PERMIT NO. **RM#24-00022**

ROSE 9A

CITY OF RICHMOND HILL
BUILDING DIVISION

SHEET TITLE: **BASEMENT PLAN ELEVATION 1**

SHEET TITLE
SECOND FLOOR PLAN
ELEVATION 2

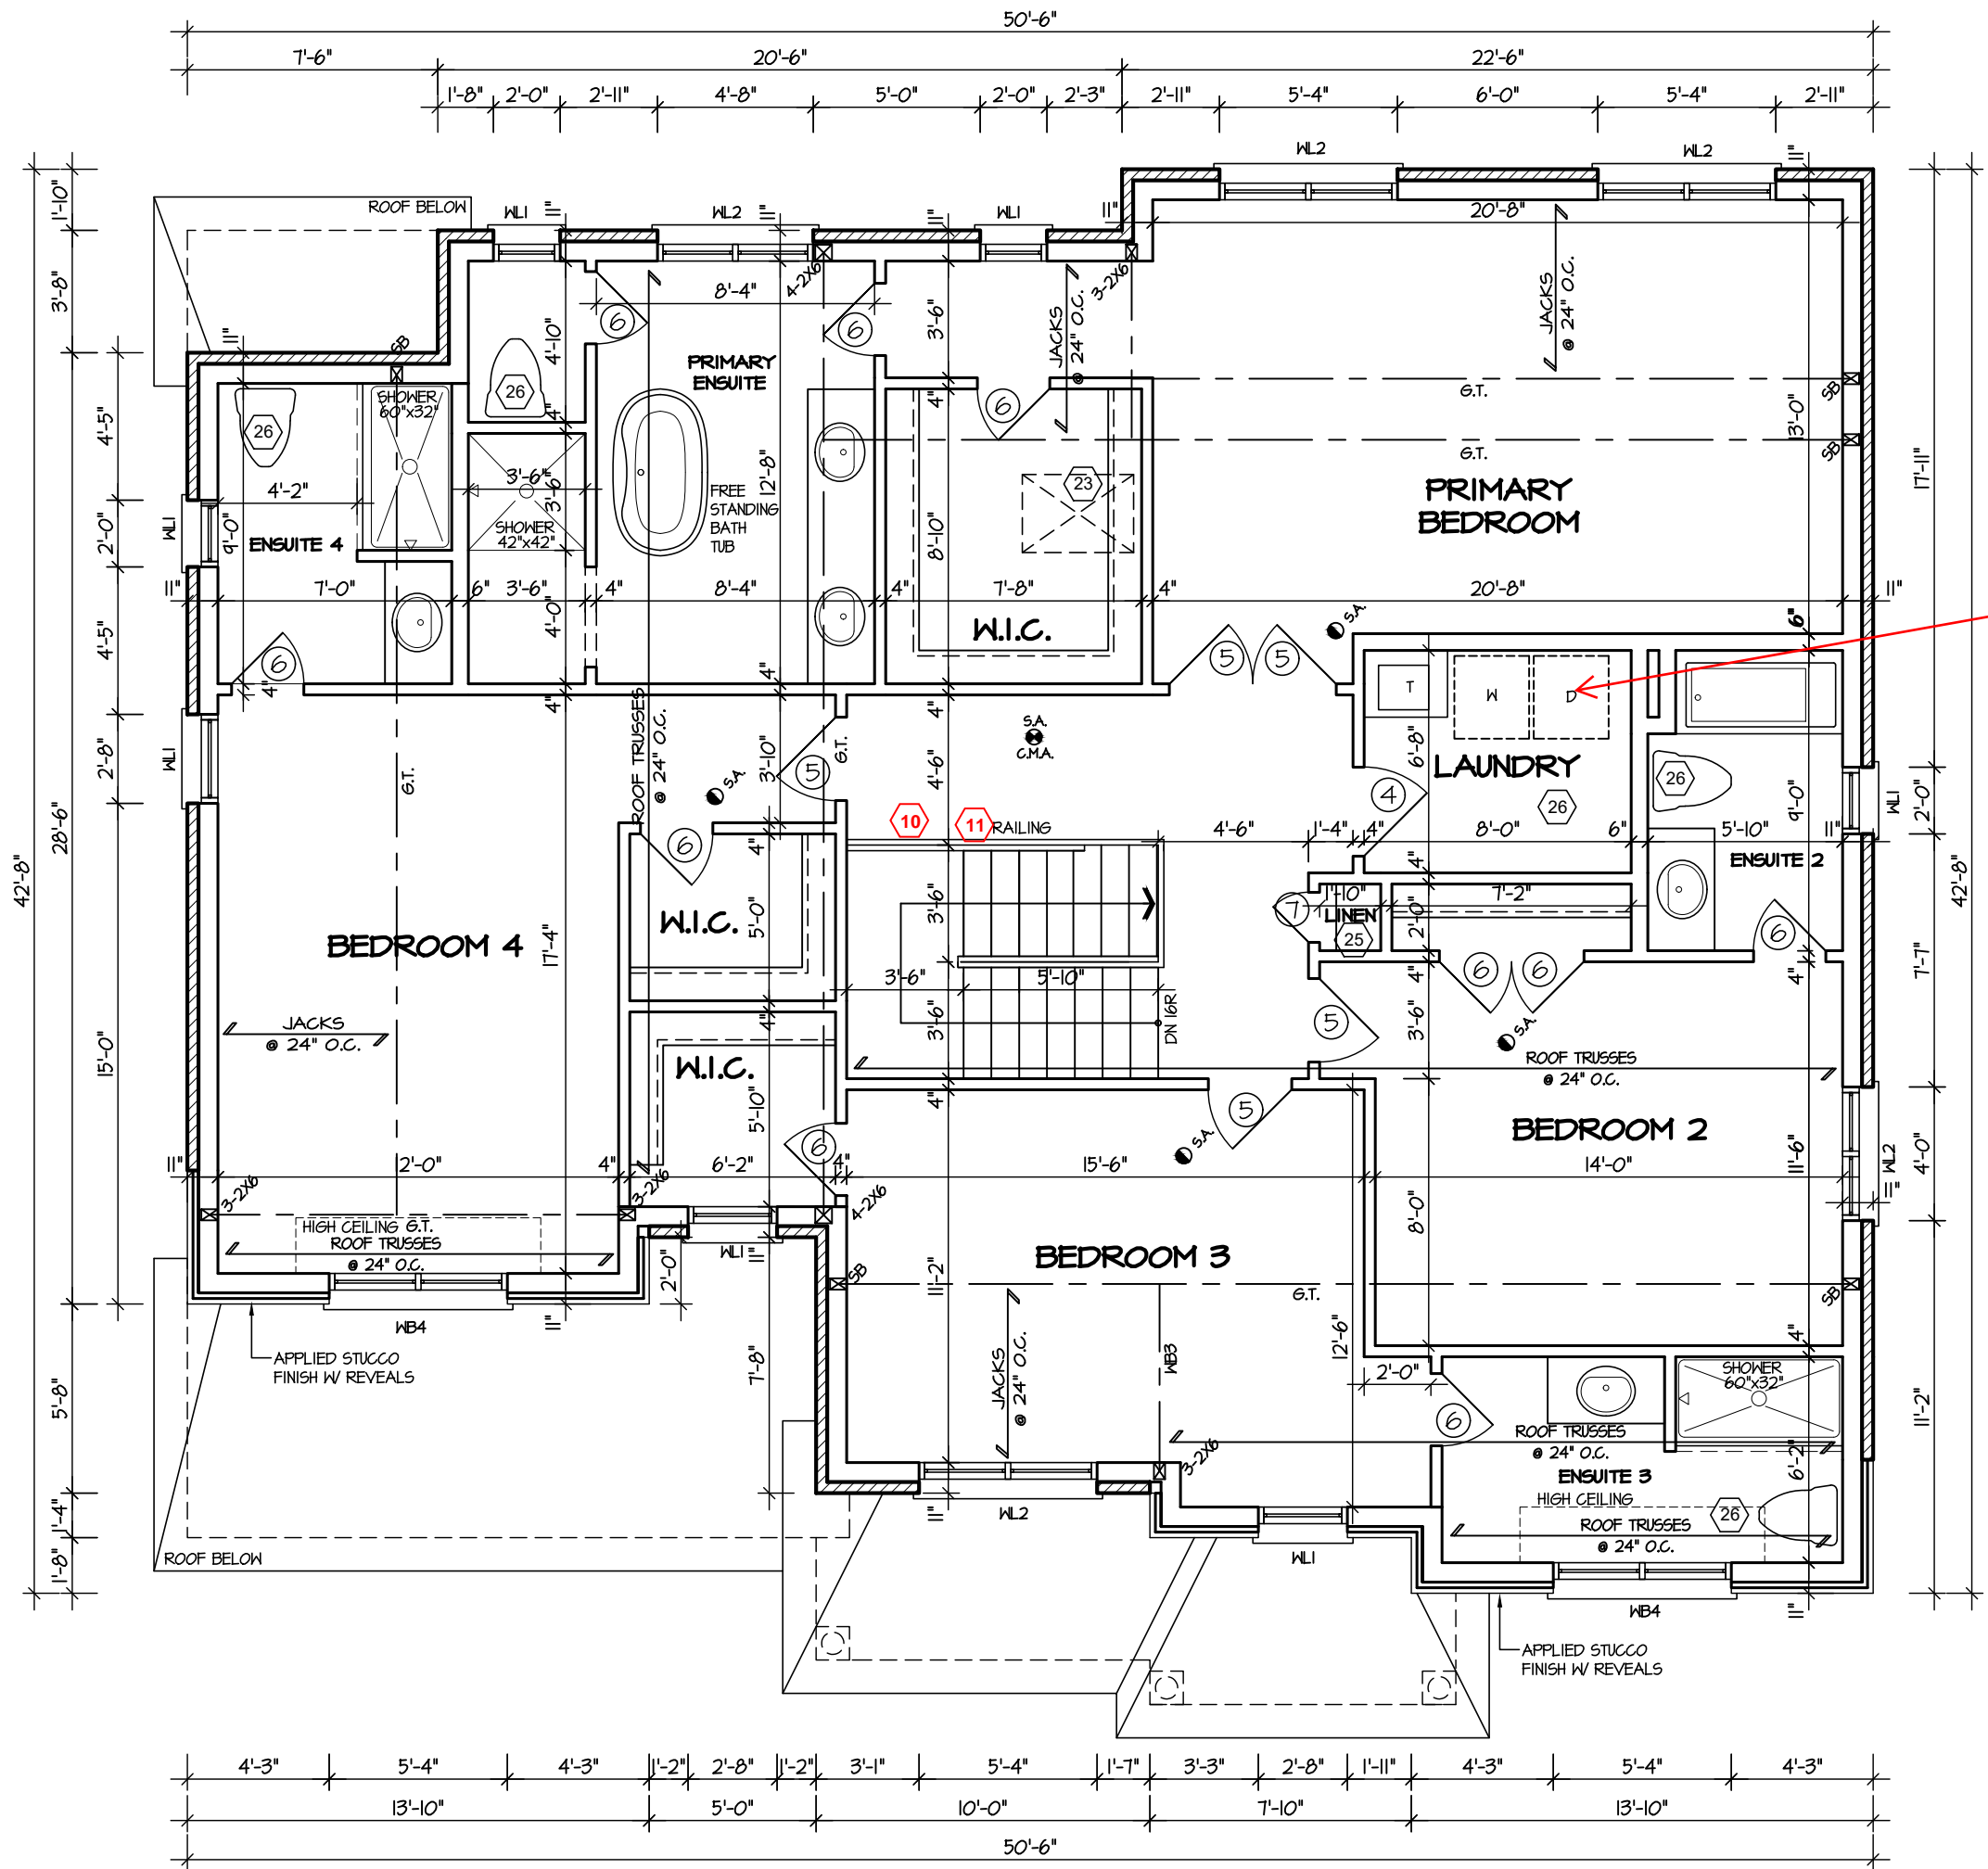
vent dryer
to exterior

SECOND FLOOR PLAN '3'

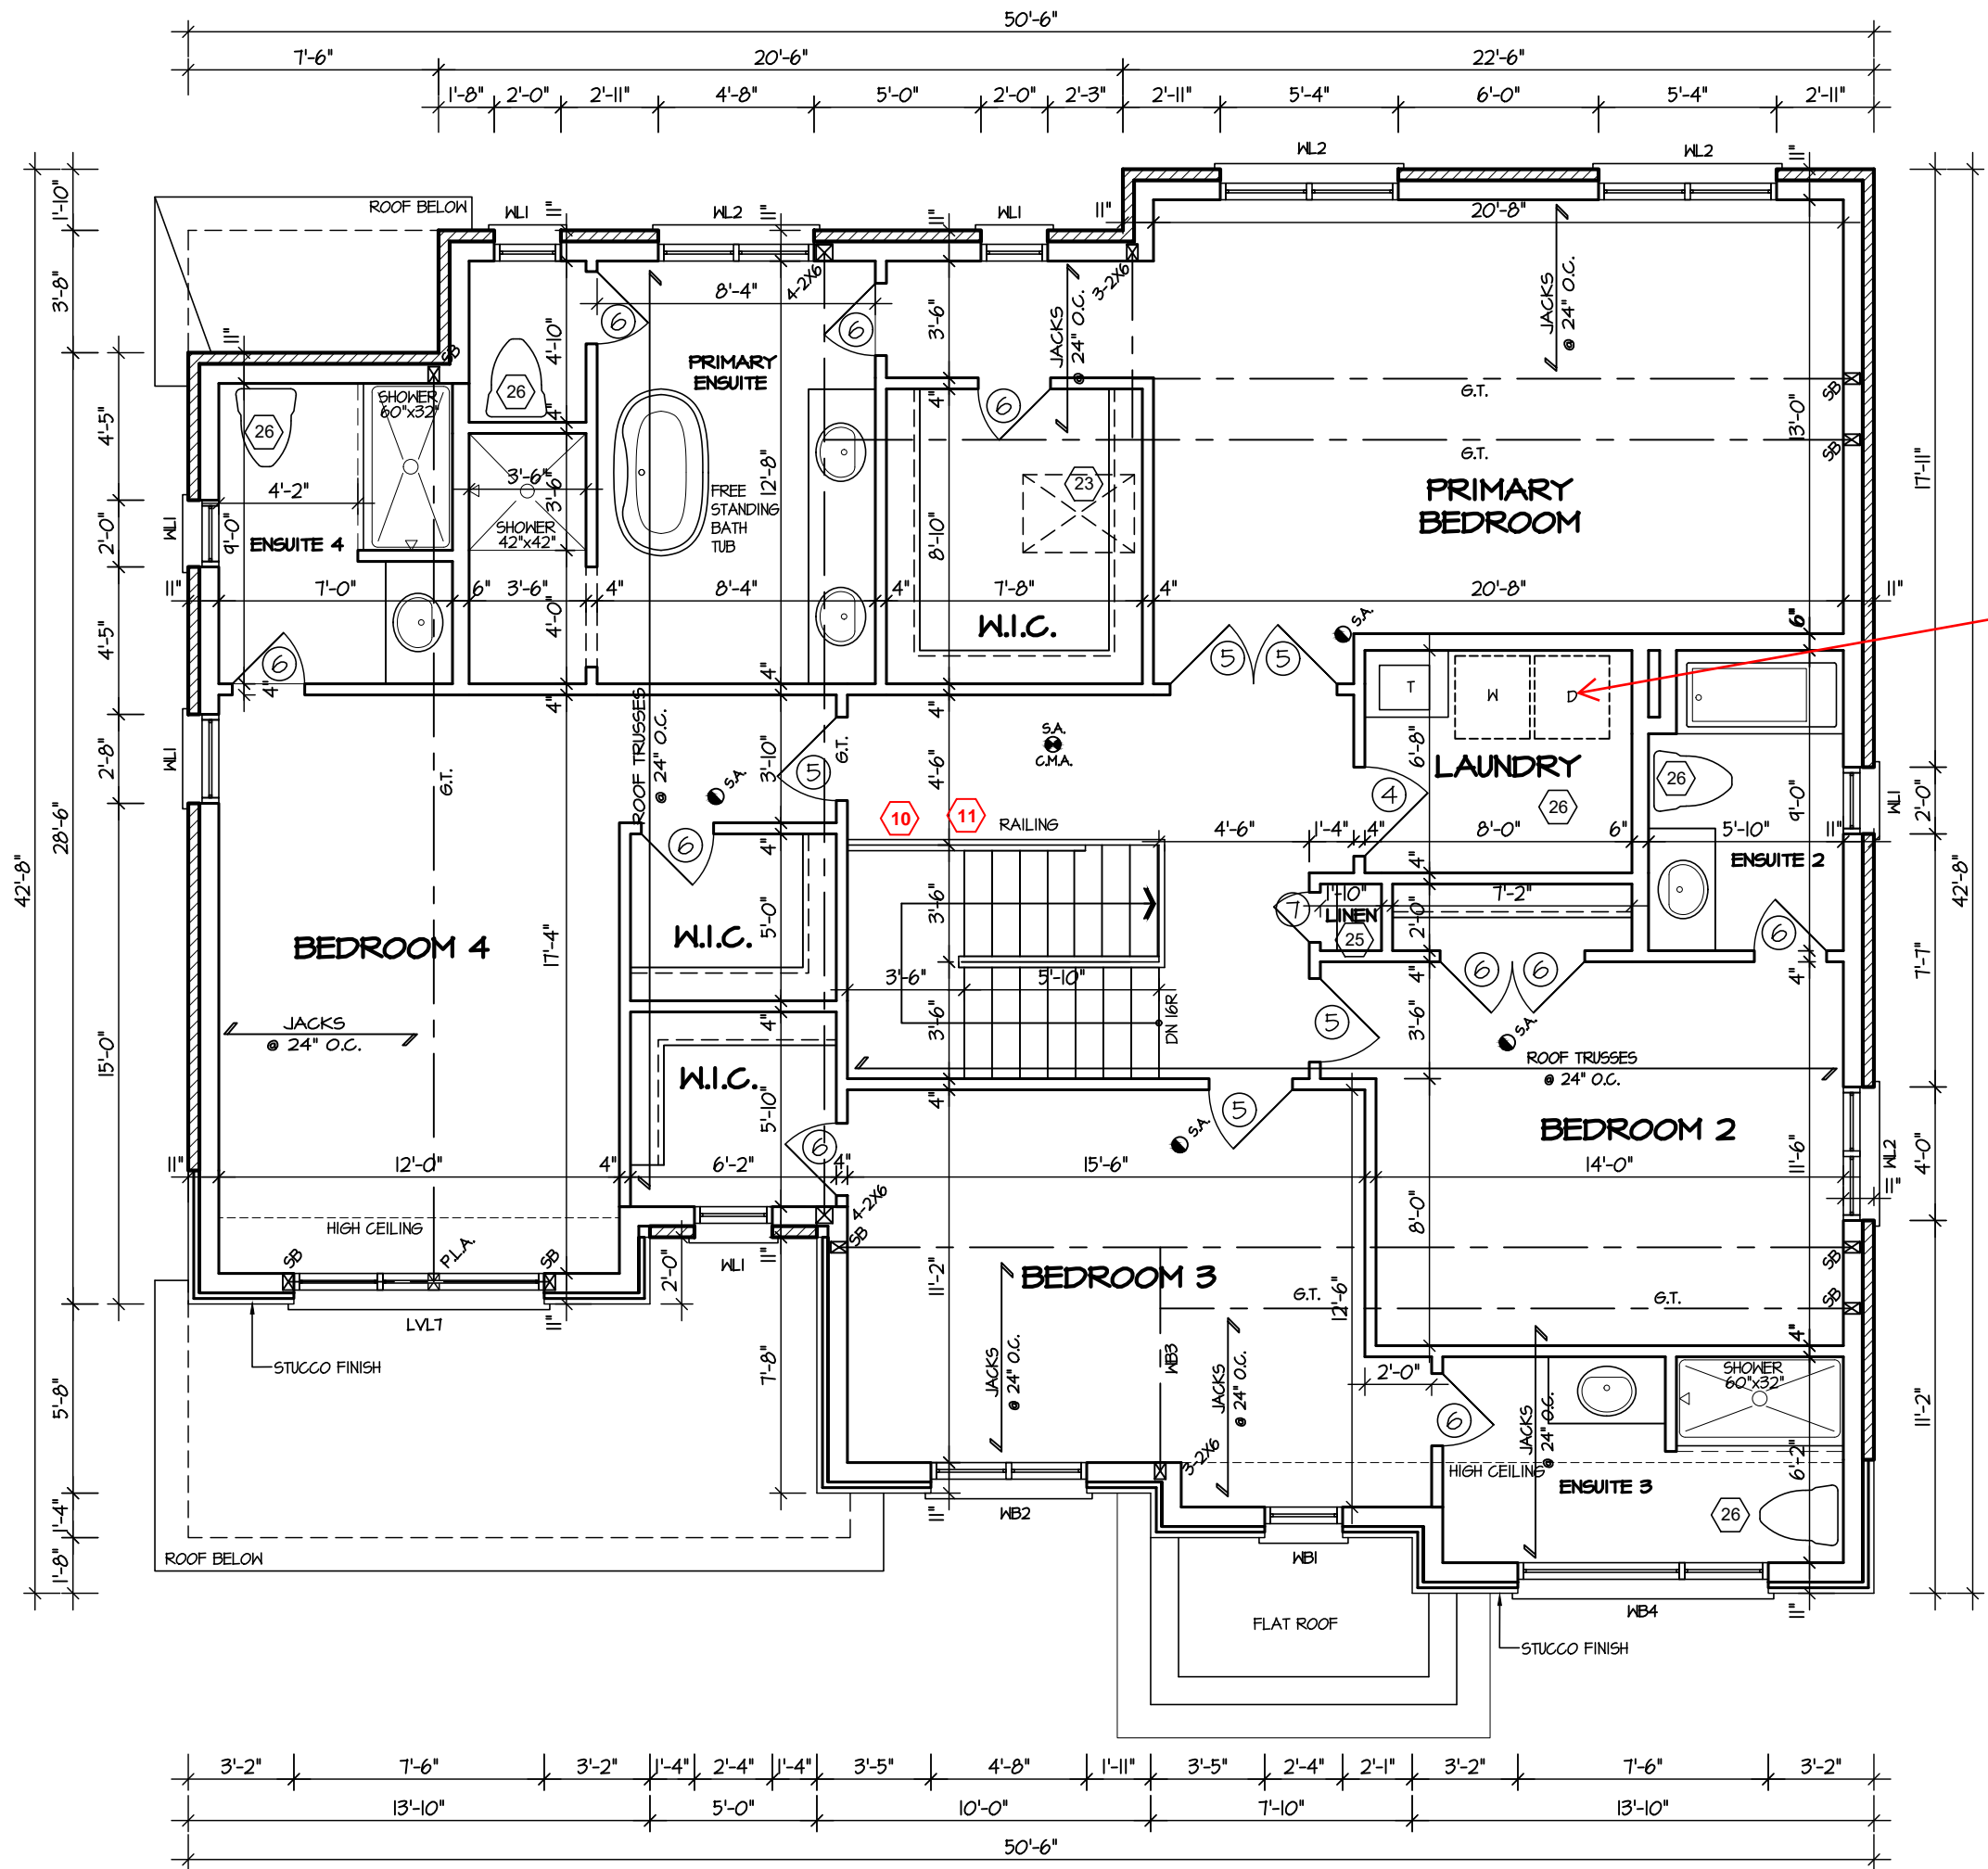
vent dryer
to exterior

PARTIAL FIRST FLOOR PLAN
WALK UP STAIR

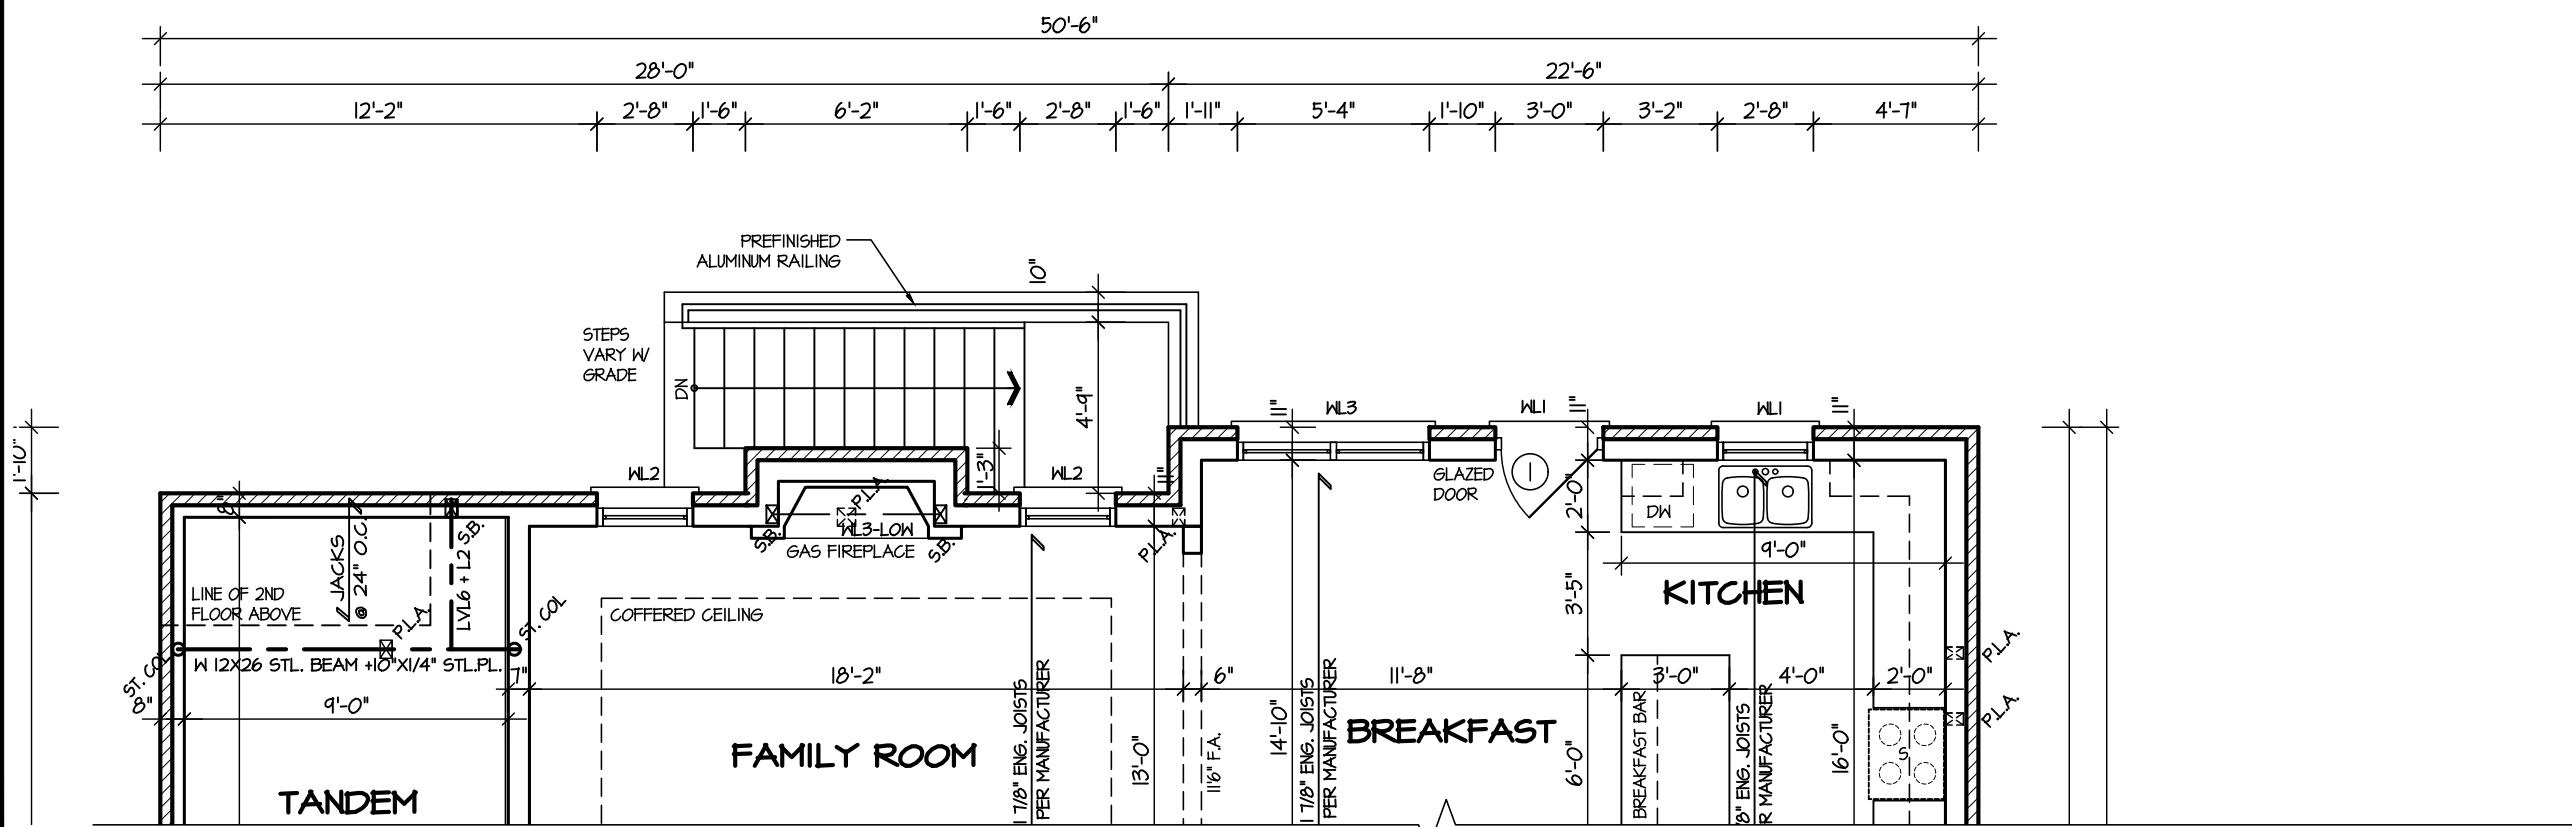
Refer to attached
detail RHB01
